# Response to Submissions

Bloomfield Colliery - Life of Mine Extension, Modification 4

Client: Bloomfield Collieries Pty Limited

15-Jun-2018

Figure 11. Predicted Water Table Drawdown Contours [m] at Registered Bores at the End of Mining (Year 2025). Posted values are specific-layer drawdowns at the base of each hole.

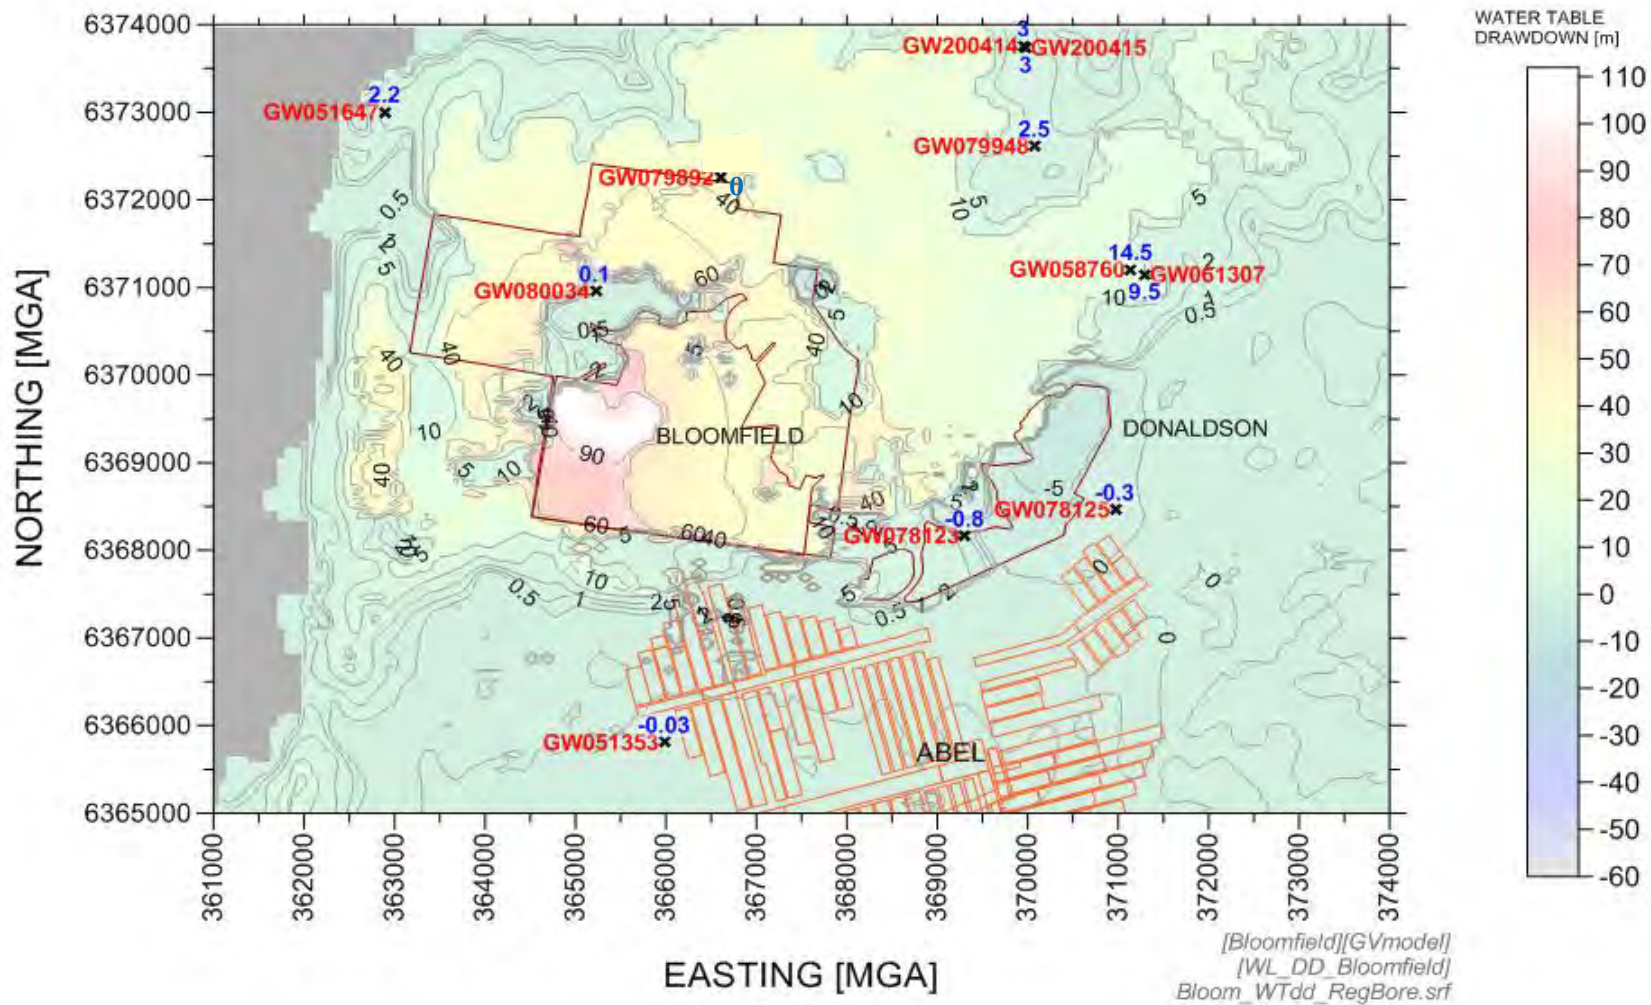
- 5.8 Baseflow Capture, last paragraph – Perhaps the words “... and therefore no impact on Hexham Swamp is predicted ...’ could be added.
- Figure 11 – This figure is misleading. It says “predicted drawdown in Layer 1 (alluvium and regolith), but it has drawdowns that greatly exceed the thickness of Layer 1. This could be interpreted by a lay reader that the alluvium is going to be massively dewatered, to greater than 100m depth. The Figure should be corrected to show actual maximum drawdowns in alluvium/regolith. Alternatively, it needs to be carefully footnoted to explain just what is being shown.

Predicted groundwater drawdowns at the end of mining at registered bores within 5 km of Bloomfield are listed in **Table 10a** for production bores and **Table 10b** for monitoring bores, and are posted on the map at **Figure 11**. These values are cumulative drawdowns from all mining activities, in the specific layer corresponding to the depth of each hole.

The contours in **Figure 11** are of water table drawdown (not layer-specific drawdown). As there is no overlap of water table effects between the various mines, the cause of the drawdown is clear from an inspection of **Figure 11** in terms of proximity to the nearest mine.

Figure D0. Predicted Water Table Drawdowns at the End of Mining (Year 2025) Showing where Layer 1 Becomes Dry

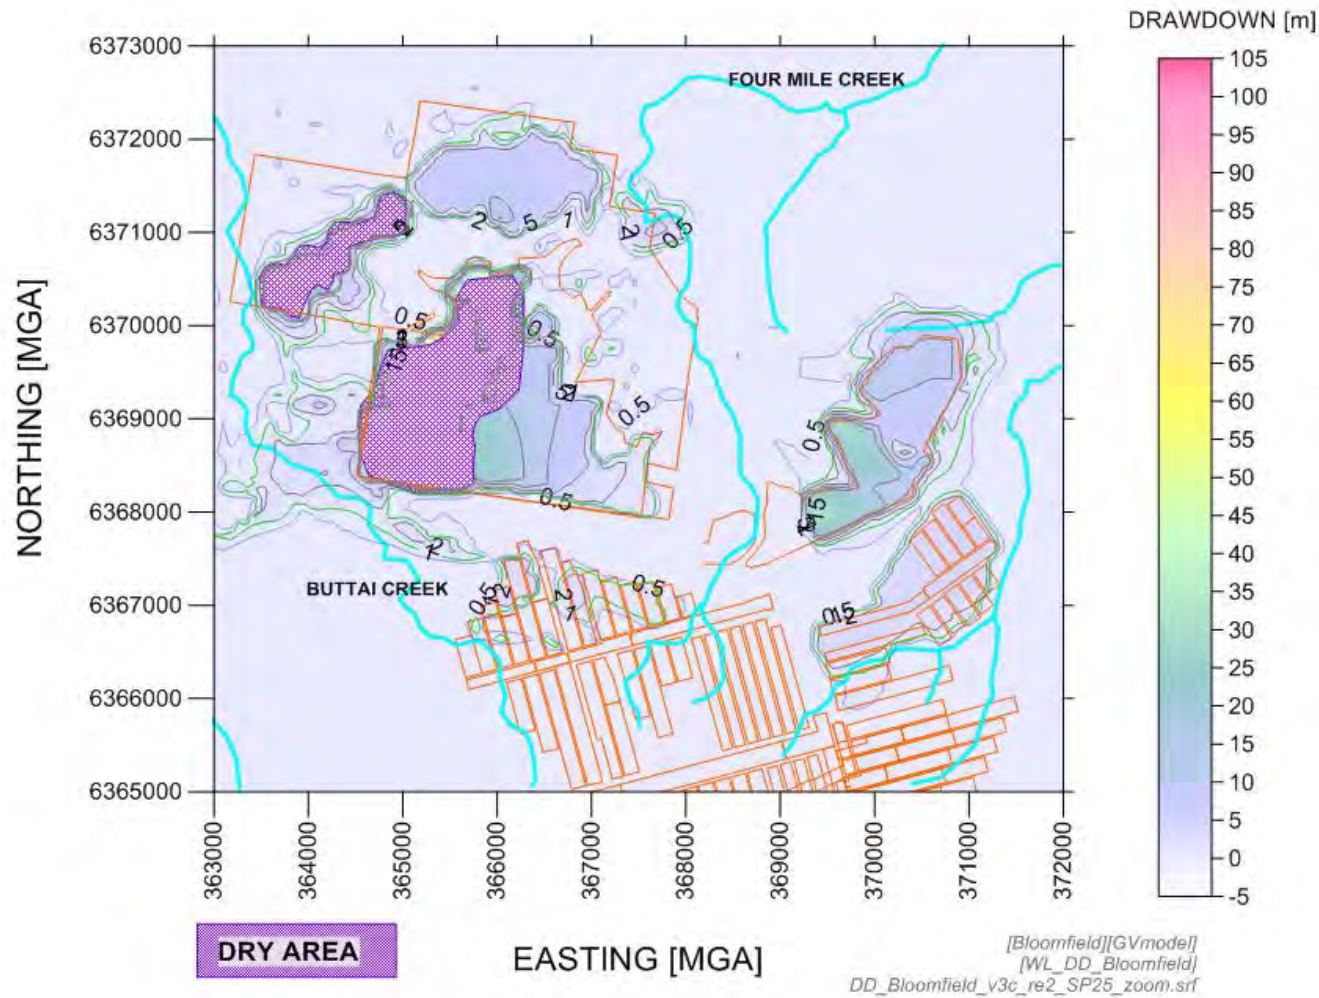
Text	28	Peter	23/04/2018	What will be the lateral extent of drawdown impact (>2m) in Layer 1?	GH	text added based onn Fig D0 of theHS report	text added as suggested
Highlight	29	Peter	23/04/2018		GH	assume this highlight is related to other comments on page 29 that have been already addressed	text amended

**Figure D1. Predicted Drawdowns in Alluvium and Regolith [Layer 1] at the End of Mining (Year 2025).**

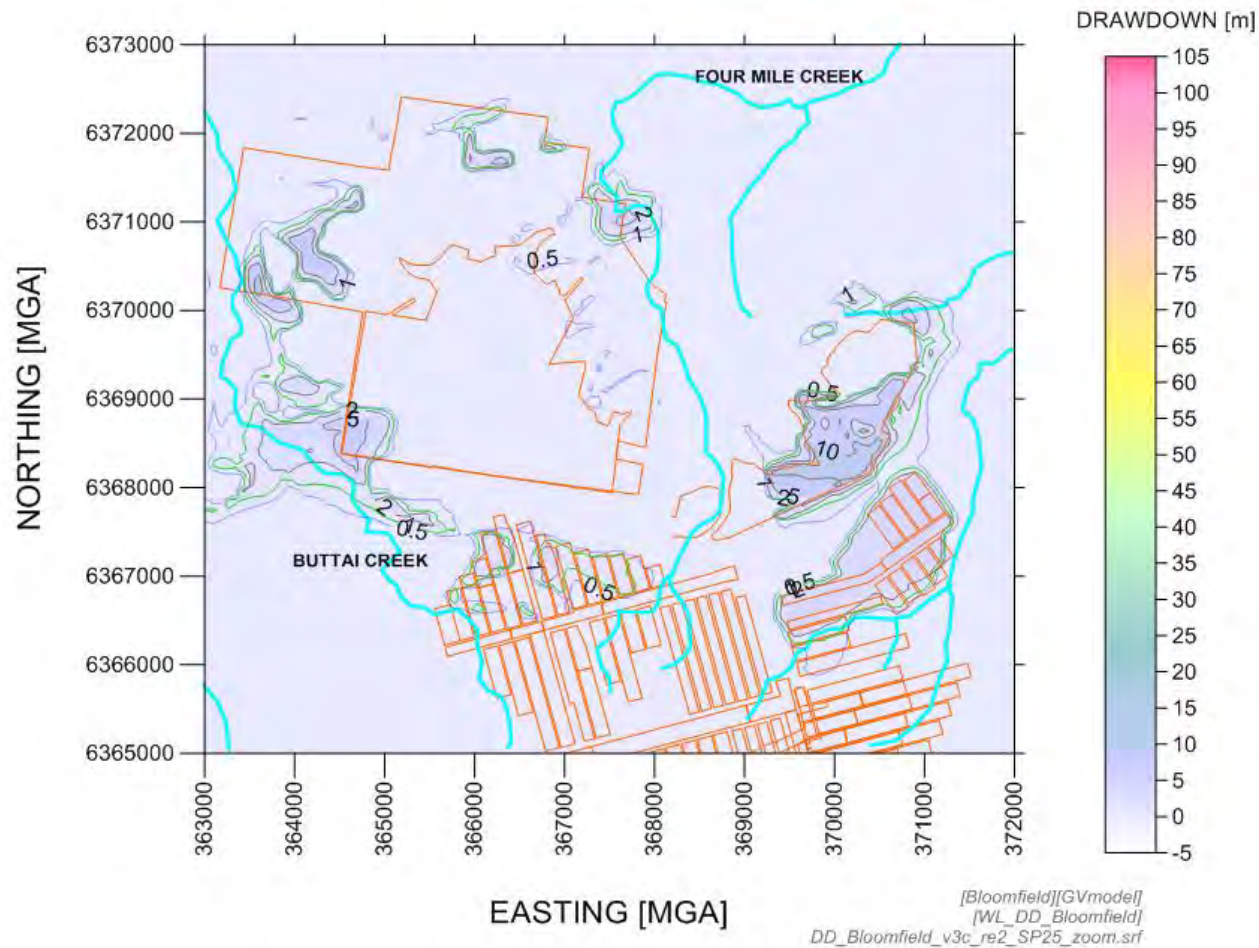
Highlight	21	Peter	Highlight	23/04/2018, 10:27:12 AM		
Text	22	Peter	Sticky Note	23/04/2018, 10:33:48 AM	Drawdown cannot be greater than 10m (max thickness of layer 1). Maybe show area where L1 cells are dry??	Corrected now. Drawdown is now defined as: $DD = IF(A>B,A,B)-IF(C>B,C,B)$ where A=Null water level; B=Bot1 elevation; C=modelled water level. Dry areas are now shown in new Figure D0.
Text	22	Peter	Sticky Note	23/04/2018, 10:35:07 AM	The drawdown responses at VW8 suggest spatial confinement may not be occurring. Is there any evidence that the dyke is a barrier?	VW8 is a long way from the dyke, though mine personnel regard it as a barrier. The VW8 heads are surprisingly low, and the model has not been able to reproduce them.
Highlight	22	Peter	Highlight	23/04/2018, 4:34:17 PM		
Text	22	Peter	Sticky Note	23/04/2018, 4:38:27 PM	Are the drawdowns in Table 11 water table drawdowns (ie Layer 1) or all layers? Is it necessary to include registered bores that are monitoring bores only? If so, they should be denoted such in the table. Also, if any bores is screened in a layer other than 1, the drawdown in that layer should be included (eg GW078123 and GW078124). Note that the drawdowns greater than 10m are not real as thickness of Layer 1 is only 10m max.	Corrected. Table 10 has been split into separate tables (a) and (b) for production and monitoring bores. The correct lithology is now listed and the drawdown in the appropriate layer is reported.

To account for a dry layer, the following definition is applied: Drawdown = IF(A>B,A,B)- IF(C>B,C,B) where A = null model water level; C = modelled water level; B = Layer 1 bottom elevation.
